# HISTORIC AND DESIGN REVIEW COMMISSION

**HDRC CASE NO:** 2023-168  
**ADDRESS:** 915 E CROCKETT ST  
**LEGAL DESCRIPTION:** NCB 576 BLK 15B LOT 18 (CROCKETT ST)  
**ZONING:** R-3, H  
**CITY COUNCIL DIST.:** 2  
**DISTRICT:** Dignowity Hill Historic District  
**APPLICANT:** Jennifer Park/PARK JENNIFER L & JEFFREY S  
**OWNER:** Jennifer Park/PARK JENNIFER L & JEFFREY S  
**TYPE OF WORK:** Construction of a 2-story, single family residential structure  
**APPLICATION RECEIVED:** April 19, 2023  
**60-DAY REVIEW:** Not applicable due to City Council Emergency Orders  
**CASE MANAGER:** Edward Hall

The applicant is requesting a Certificate of Appropriateness for approval to construct a 2-story, single-family residential structure on the vacant lot at 915 E Crockett, located within the Dignowity Hill Historic District.

# PARK CUSTOM RESIDENCE

1 FRONT ELEVATION - SOUTH

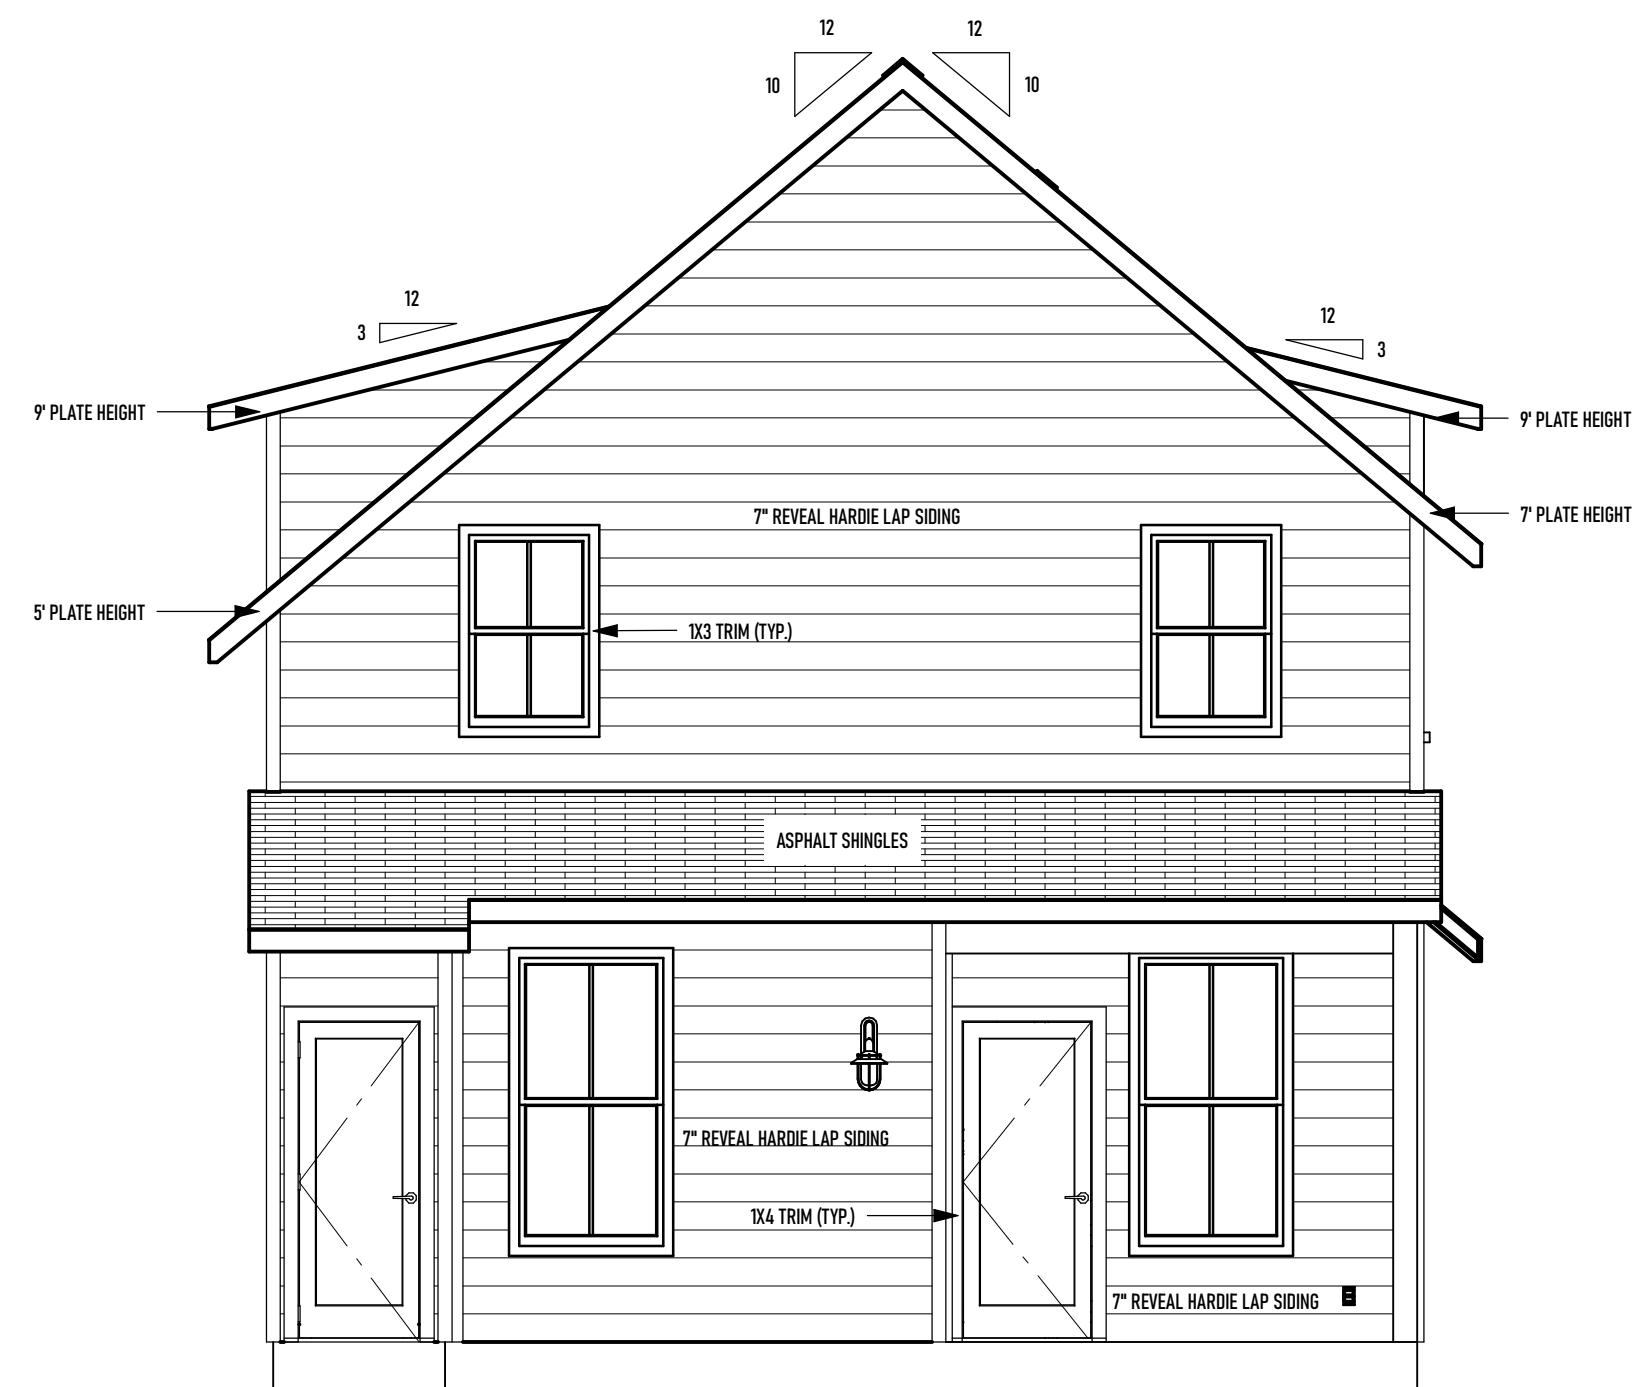
- j. MATERIALS – The applicant has proposed materials that include composite lap siding, composite board and batten siding, an asphalt shingle roof, and aluminum clad wood windows. The applicant has noted that the proposed lap siding will feature a smooth finish and a five (5) inch exposure. Additionally, the applicant has noted that the proposed board and batten siding will feature boards that are twelve (12) inches wide and battens that are 1.5 inches wide. Staff finds that a five (5) inch exposure for lap siding is appropriate.

- m. PORCH – The applicant has proposed a front porch that features distinct massing and form. Generally, staff finds the proposed porch to be appropriate and consistent with the Guidelines. Staff finds that columns should be six inches square with capital and base trim. A final column detail is to be submitted to OHP staff for review and approval.

- i. That all lap siding feature an exposure of five (5) inches, as noted in finding j. Board and batten siding should feature smooth boards that are approximately 12 inches in width with battens that are approximately 1.5 inches in width. All siding should be smooth with no faux wood grain profiles.

- iii. That a final porch column detail be submitted to OHP staff for review and approval, as noted in finding m. Columns should be six (6) inches square with capital and base trim.
